CALIFORNIA COASTAL COMMISSION

**Tu 18d****STAFF REPORT: REGULAR CALENDAR****APPLICATION NUMBER:** 5-02-353

APPLICANT: Roger Lowenstein**AGENT:** Christopher V. Ward, AIA**PROJECT LOCATION:** 21 Reef Street, Venice, City of Los Angeles.

PROJECT DESCRIPTION: Demolition of a one-story single family residence, and construction of a four-level, 38.5-foot high, 3,669 square foot single family residence with a four-car garage in the basement.

Side Elevation of Proposed House

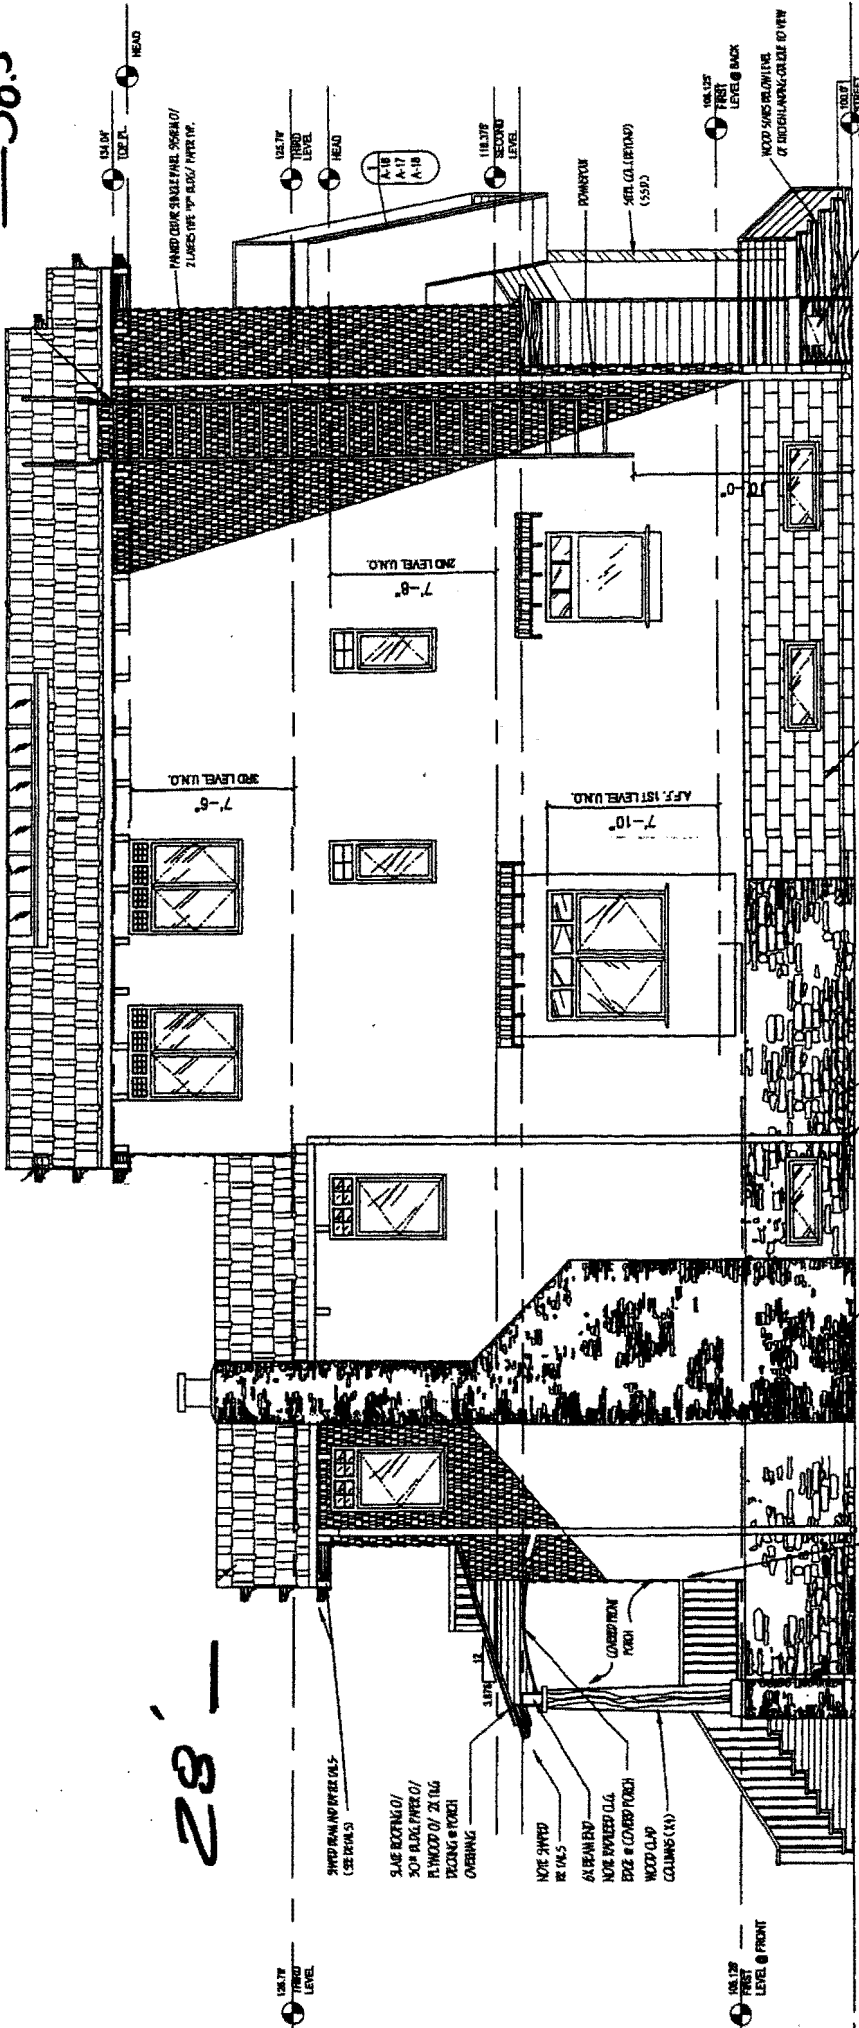
The structure to be demolished is a fourteen-foot high single family residence. The proposed new residence is a four-level, 38.5-foot high, 3,669 square foot single family residence (Exhibit #6). A four-car garage, accessed from the rear alley, is proposed in the basement of the proposed house. The front porch of the proposed house would be set back sixteen feet from the Reef Street right-of-way in order to preserve the mature trees that exist in the front yard area of the lot (Exhibit #4). The second story of the proposed house would be set back 22.67 feet from the right-of-way, and the third story would be set back forty feet, creating a stepped back design (Exhibit #5).

In order to protect the unique character of the Venice walk streets, the certified LUP limits the height of development along these walk street to a maximum of 28 feet, which is less than the 35-foot height limit for Marina Peninsula properties not located along a walk street or a sensitive habitat area (Exhibit #2). The proposed 38.5-foot high project would exceed the walk street height limit by more than ten feet (Exhibit #5).

Policy II.C.10 requires that new residential development along walk streets enhance both public access and neighborhood character. The proposed 38.5-foot high building would not enhance neighborhood character, as it would be taller than many of the other buildings on Reef Street and other neighborhood walk streets. Taller buildings would be out of proportion to the pedestrian walkways and taller buildings require wider streets to service them. The conversion of the walk streets to wider streets for emergency access would adversely affect scenic and visual qualities of the unique coastal area. Therefore, allowing new buildings to exceed the height limit would set a bad precedent. The proposed 38.5-foot high building exceeds the 28-foot height limit called for by LUP Policy I.A.7.c.

Front (Reef St.) Elevation

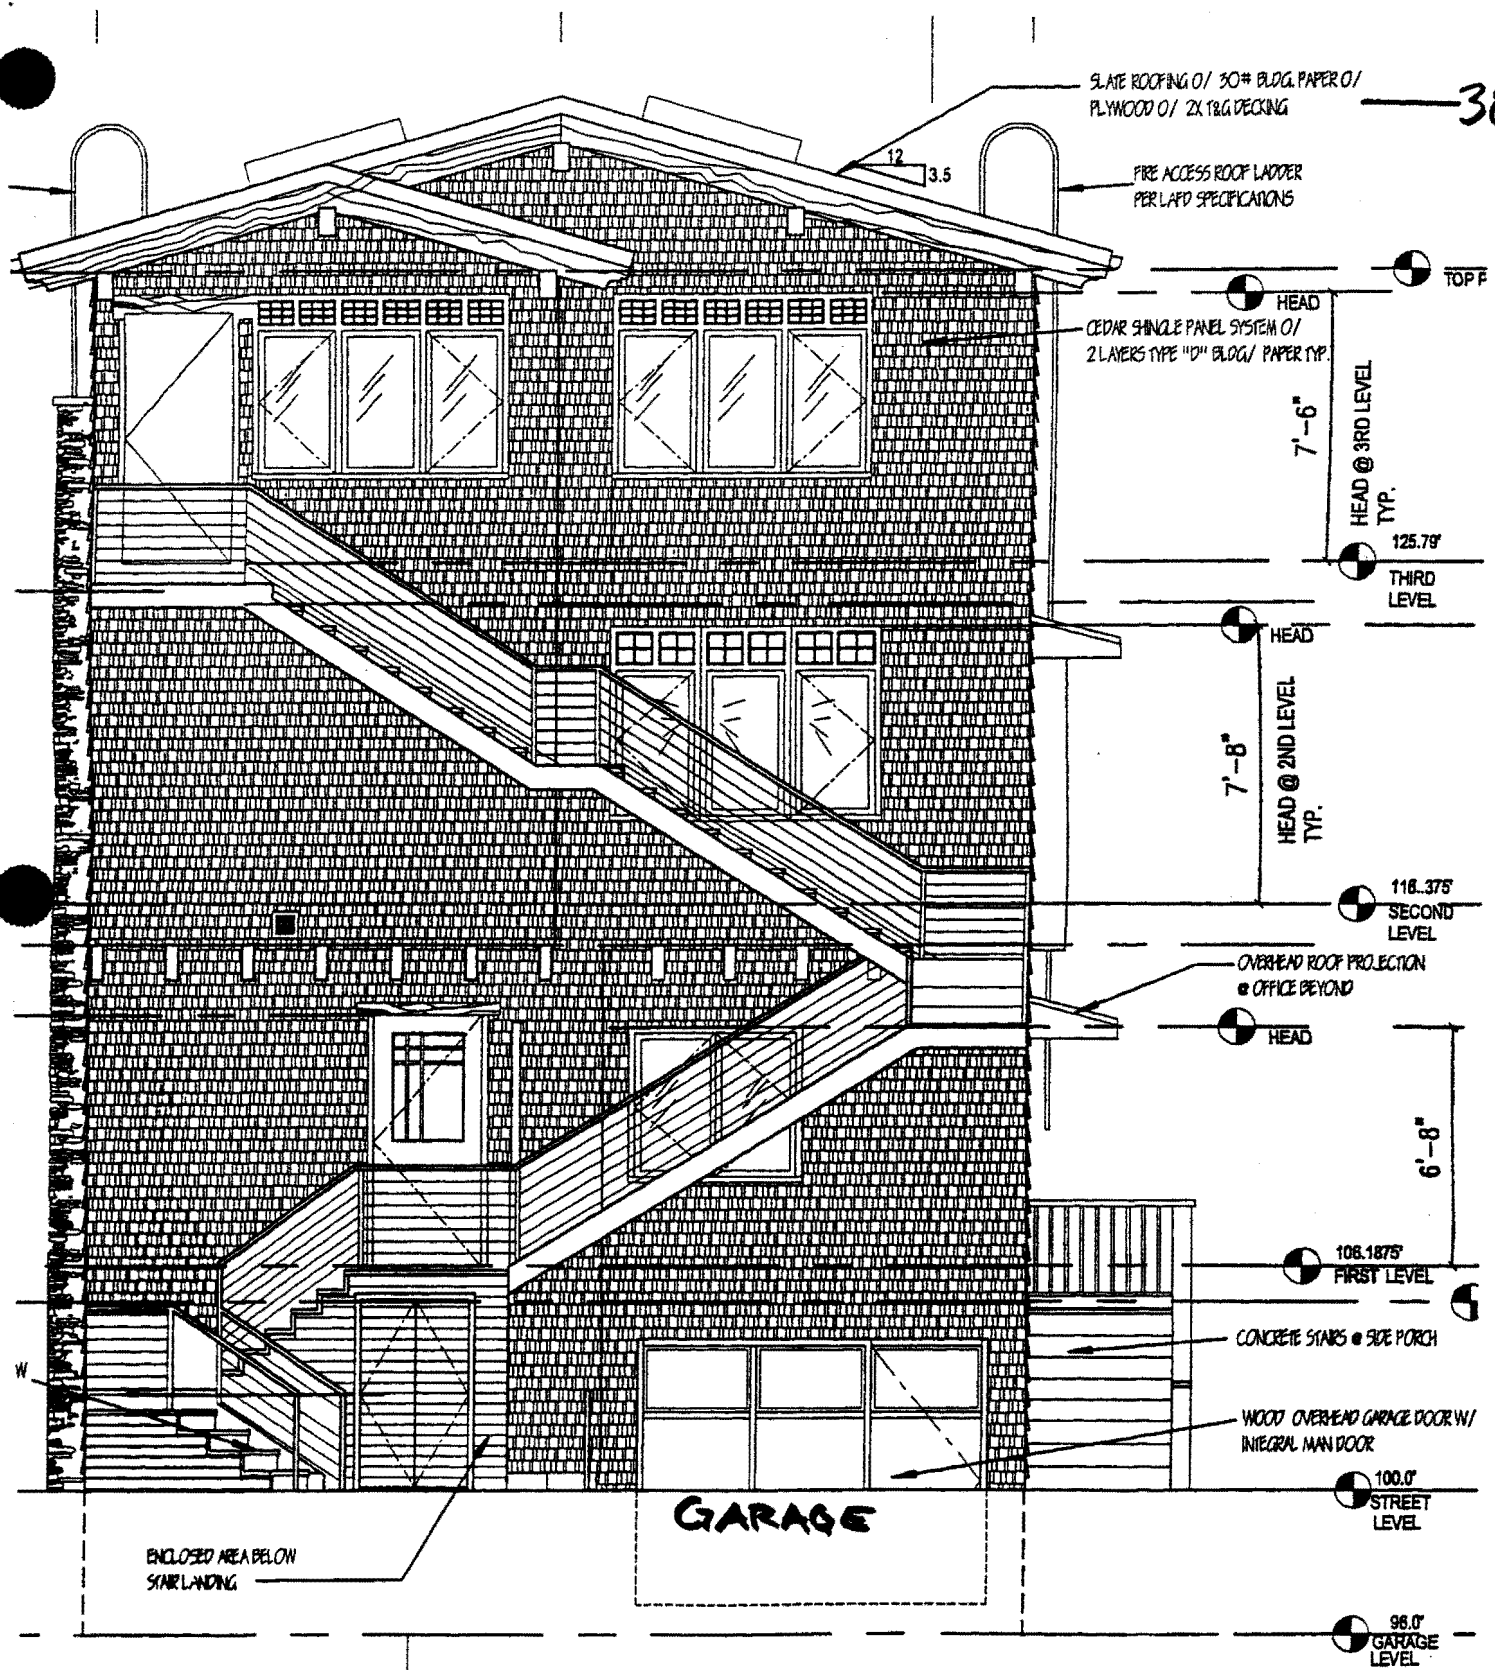
1. Reef Street is not a walk street and is being used for parking by vehicles (Exhibit #8).
2. The applicant is proposing only one residential unit when the LUP allows two units per lot.
3. The design of the proposed house is set back more than required from the walk street, thus reducing the mass of the structure from what is allowed by City zoning.
4. The 38.5-foot high portion of the proposed structure is set back almost 23 feet from the Reef Street right-of-way, while the front portion of the proposed house is only 28 feet high (Exhibit #6).
5. The Fire Department has approved the proposed design (Exhibit #8, p.3).

The single family home proposed for 21 Reef Street is a tiered design, three stories and 38' tall for the rear portion only, lodged between a 40' tall multi unit condominium building to the east (Fig. 5B) and a 43' foot tall block designed dwelling to the west (Fig. 5A). The front of the proposed structure is 28' feet tall and responds in design and height to the home at the west end of the block, which is a shingle style craftsman home. In this regard, the proposed home is not as tall as the structures adjacent to it, but is compatible to them in height and responds in character to the original homes built in the Venice community.

CONDOMINIUM ADJACENT TO EAST
PHOTO TAKEN FROM ALLEY

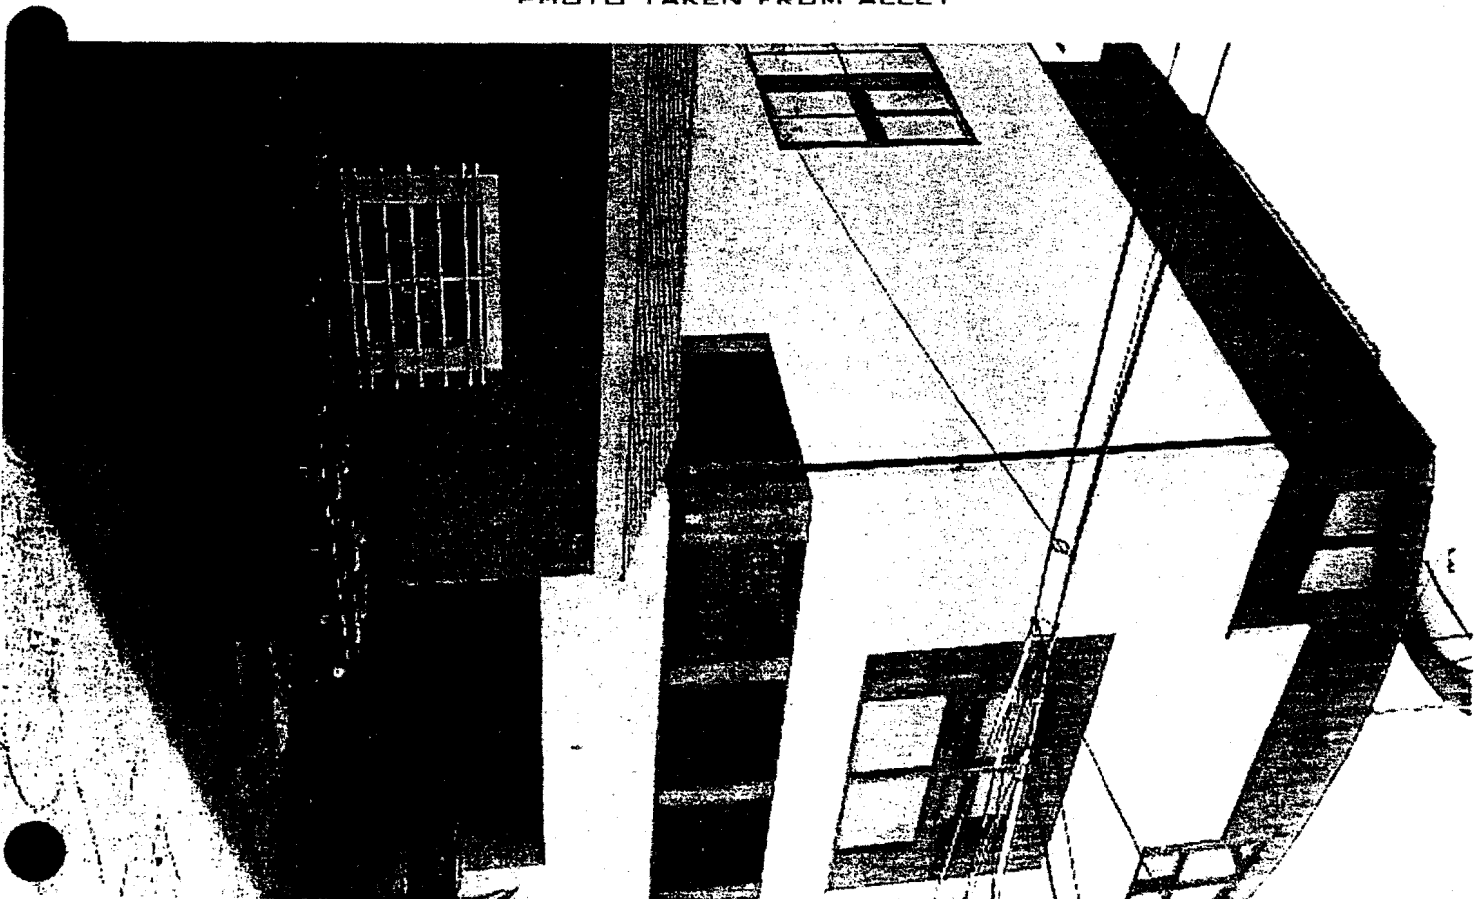
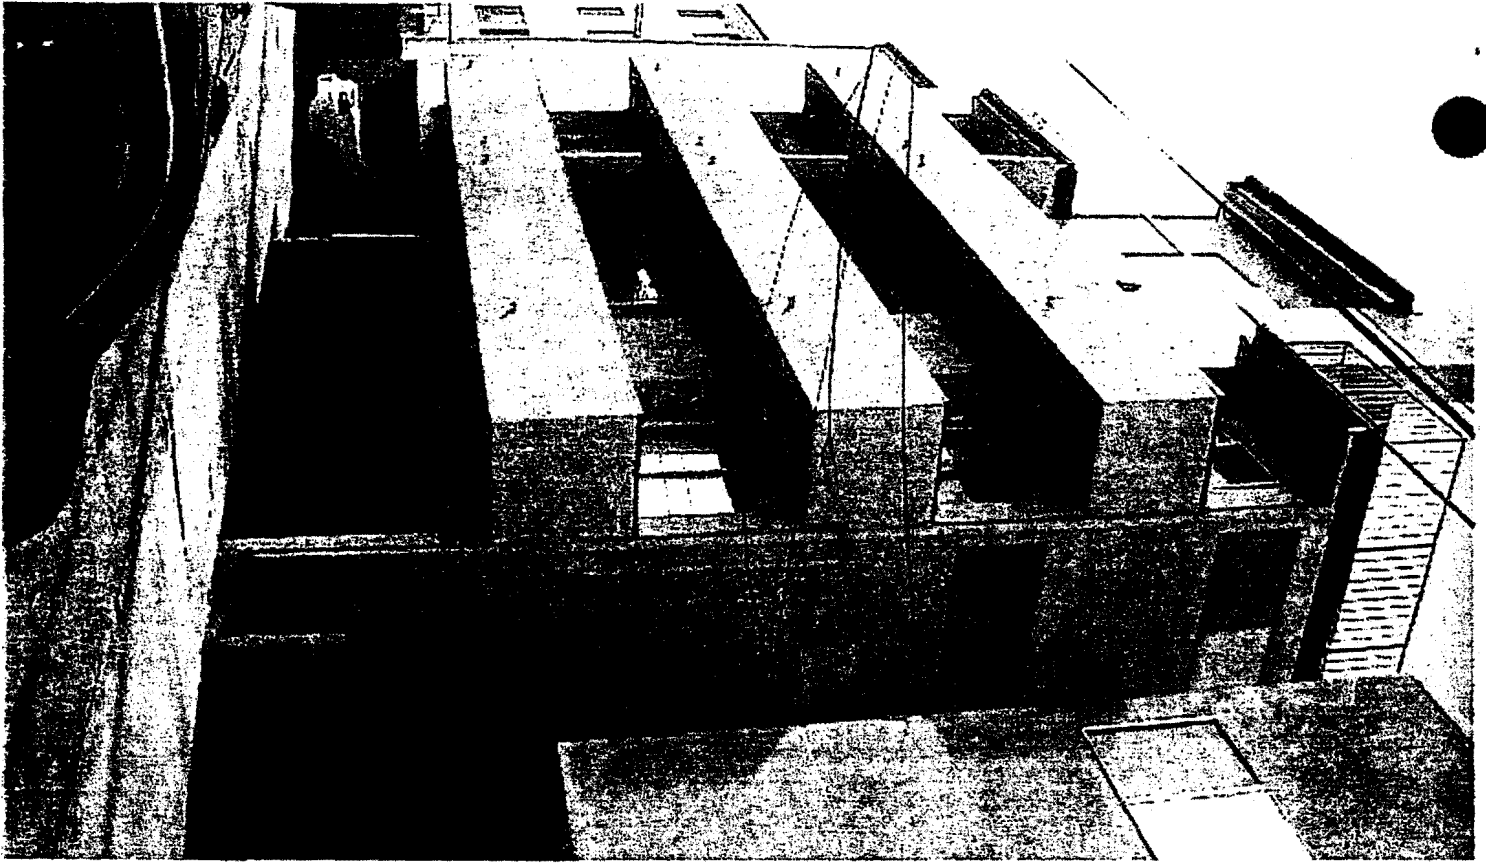
Views and access to the Coastal Area are not affected by the proposed home. The structure to the east, a four story multi-unit condominium building, has views directly to the west of the three story 43' tall dwelling which will sit to the west of the proposed home. The roof decks of the condominiums are still higher than the roof of the proposed home and views to the beach and waterfront are not disturbed by the proposed new structure.
